Program Bulletin

SB-10056151-3195

SUBJECT: Seat Mounted Side Impact Airbag Connector

**MODELS: 2014 Chevrolet Silverado 1500
 2014 GMC Sierra 1500**

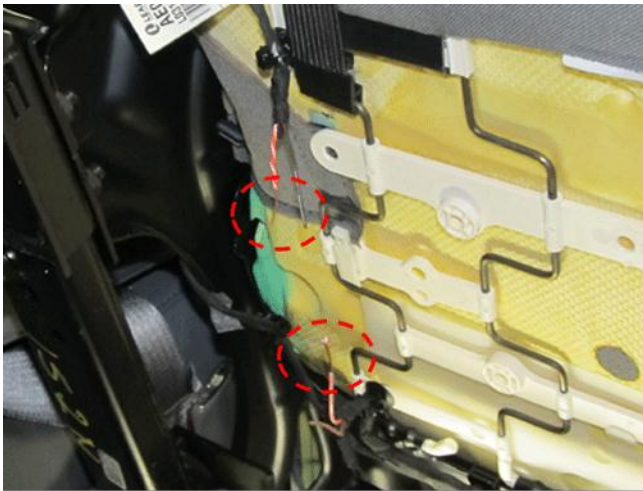
1. Starting on the passenger seat, locate the inboard grey SIAB harness connector (1) on the underside of the seat cushion.

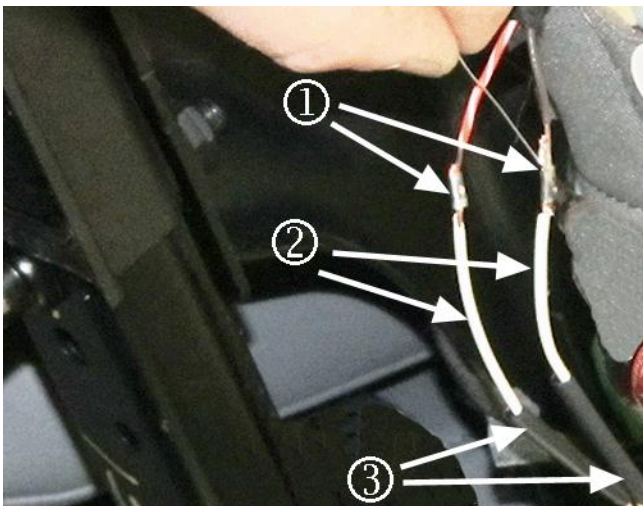
4. As shown on the passenger side connector above, cut the wires from the harness connector as close to the connector housing as possible to minimize wire length loss.

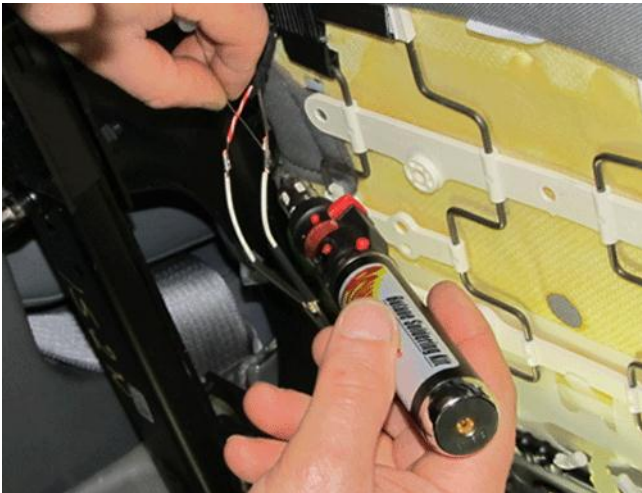
6. Add one approximate 38 mm (1.5 in) section of heat shrink tube (3) to each of the four wires.

7. Add an approximate 102 mm (4.0 in) length jumper wire (2), obtained locally, to reconnect each set of cut wires.
 - 7.1 Strip off approximately 10mm (0.40 in) of insulation from each end of the jumper wire.
 - 7.2 Fold over one end of the jumper wire and position it together with the folded over end of one the cut wires.
 - 7.3 Crimp a splice clip (1) over the joined wires using Special Tool J-38125-8, nest F. Verify the crimp quality.
 - 7.4 Fold over the other end of the jumper wire and position it together with the folded end of the remaining wire.
 - 7.5 Crimp a splice clip (1) over the joined wires using Special Tool J-38125-8, nest F. Verify the crimp quality.
8. Repeat step 7 on the second cut wire.

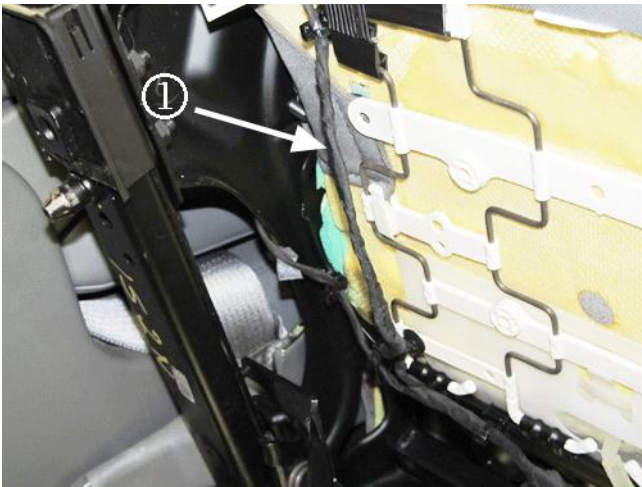
9. Solder all four crimp and splice clips using the Ultratorch, part number J-38125-5, or another butane fueled soldering iron.

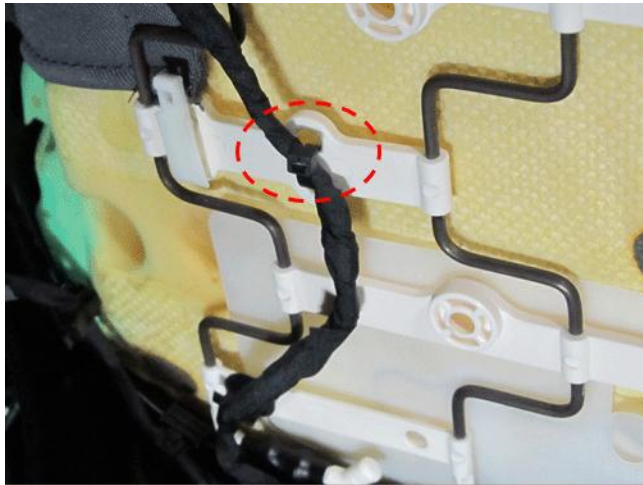
12. Wrap yellow electrical tape over the polyester electrical tape or black electrical tape.

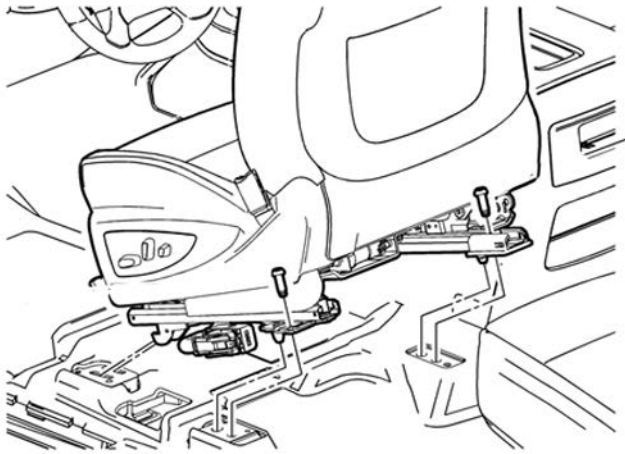
Note: The graphic above is for illustration purposes only to show the tie strap location. In this repair, the harness would have already had the yellow tape applied in the previous step.

13. Using the original mounting hole for the removed connector, secure the harness in position using a nylon tie strap.
